## Access Compliance Report Public Rights-of-Way (Curb Ramps)

Intersection ID: 10714 Main Street: MULBERRY\_CHURCH\_RD Cross Street: S\_I-85\_EXIT\_33\_RA Location: N/A

ADA ID: BAF64FB68005 Ramp Type: Perp Initial Pass/Fail: Fail Overall Compliance: No Severity Score: 21.25

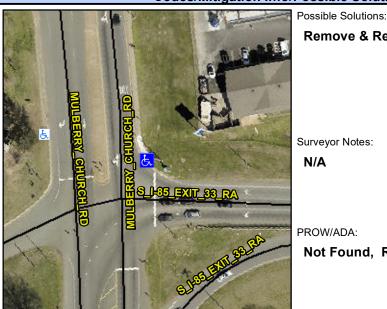
Possible Solutions.
Remove & Replace Entire Ramp.
Surveyor Notes:
N/A
PROW/ADA:
Not Found, R304.5.1, R304.2.2
Not 1 Julia, 11304.5.1, 11304.2.2

Field Measurements/Component Compliance						
Compliance Description Dat		Data	Compliance Description		Data	
N/A	Ramp Length (in)	60.0	No	Ramp Slope (%)	9.3	
No	Ramp Width (in)	36.0	Yes	Ramp XSlope (%)	1.3	
N/A	Flare Type LT	N/A	N/A	Flare Type RT	N/A	
N/A	Flare Slope LT (%)	N/A	N/A	Flare Slope RT (%)	N/A	
N/A	Flare Traversable LT?	N/A	N/A	Flare Traversable RT?	N/A	
N/A	Landing Length (in)	N/A	N/A	DWS Provided?	N/A	
N/A	Landing Width (in)	N/A	N/A	DWS Contrast?	N/A	
N/A	Landing Slope (%)	N/A	N/A	DWS Length (in)	N/A	
N/A	Landing X Slope (%)	N/A	N/A	DWS Full Width?	N/A	
N/A	Landing Curb? (Y/N)	N/A	N/A	DWS Offset (in)	N/A	
N/A	Shared Landing?	N/A				
N/A	Gutter Ponding?	N/A	N/A	Gutter Slope (%)	N/A	
N/A	Gutter Lip Ht (in)	N/A	N/A	Gutter X Slope (%)	N/A	
N/A	Painted X Walk1?	No	N/A	Painted X Walk2?	N/A	
	X Walk 1 Direction	To W		X Walk 2 Direction	N/A	
N/A	X Walk 1 Width (in)	N/A	N/A	X Walk 2 Width (in)	N/A	
	X Walk 1 Slope (%)	1.0		X Walk 2 Slope (%)	N/A
